# SERVICE BULLETIN

## REPLACEMENT OF WASHER PART NO. 944072 (FLY WHEEL HUB) FOR ROTAX® ENGINE TYPE 912 AND 914 (SERIES)

SB-912-058

SB-914-041

**Fig. 1**

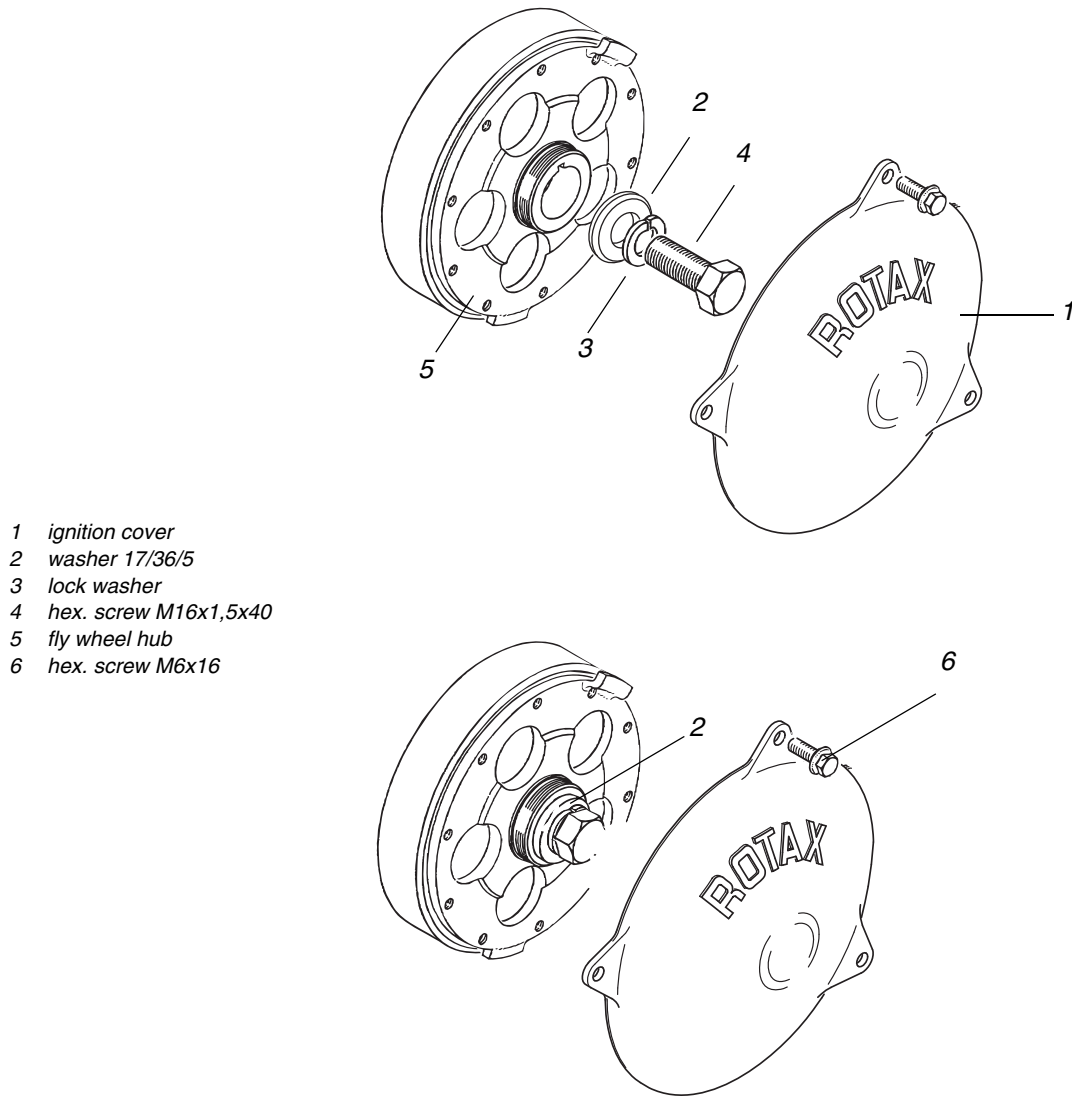
A deviation in hardening process could cause an exceeding of hardness of certain washer. This deviation could lead to cracks in the washer and could cause loosening of fly wheel, ignition failure or engine damage.

See fig. 1.

1. Remove ignition cover (1).
2. Lock the crankshaft in accordance with the relevant Maintenance Manual (Line).
3. Remove hex. screw (4) in accordance with the relevant Maintenance Manual (Heavy).

■ CAUTION: If the fly wheel hub has loosened during the disassembly and/or in case of doubt, then remove, clean and install the fly wheel hub in accordance with the relevant Maintenance Manual. In this case the tightening torque is 45 Nm (33.2 ft.lb) + 180° angle to rotation.

■ CAUTION: During installation the new washer (2) part no. 944072 must be used.

4. Install hex. screw (4). **Tightening torque 120 Nm (89 ft.lb).**

5. Remove locking pin of crankshaft in accordance with the relevant Maintenance Manual.
6. Check trigger coil gap, if necessary adjust it in accordance with the relevant Maintenance Manual.
7. Install ignition cover (1). The hex. screws (6) are locked with Loctite 221. Tightening torque 5 Nm (44 in. lb.).
